## PRODUCT / PROCESS CHANGE NOTIFICATION

**PCN#2501005**

**PCN Subject: Change Assembly Site for Package TO-252AA Series**

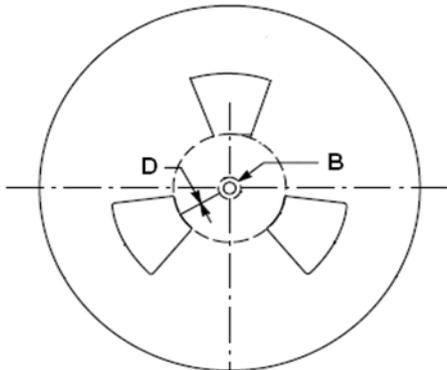
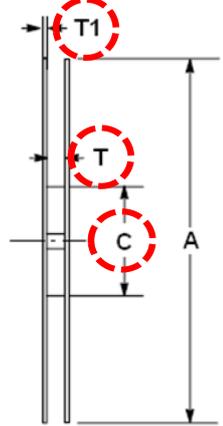
In order to respond to customer requirements, PANJIT will transfer the production of TO-252AA from GEM Electronics (Shanghai) Co., Ltd. to PANJIT Electronics (WUXI) Co., Ltd.

PANJIT Electronics (WUXI) Co., Ltd. has developed mature production capabilities for TO-252AA products, which can enhance our supply and service capabilities. Products manufactured at PANJIT Electronics (WUXI) Co., Ltd. are form, fit, and function compatible with those from the currently qualified sites. As part of the qualification process for PANJIT Electronics (WUXI) Co., Ltd., the suppliers of key materials for production, including the lead frame, wire, epoxy molding compound, carrier tape, and ending tape have been qualified to ensure consistent quality and performance. Please refer to the change information below.
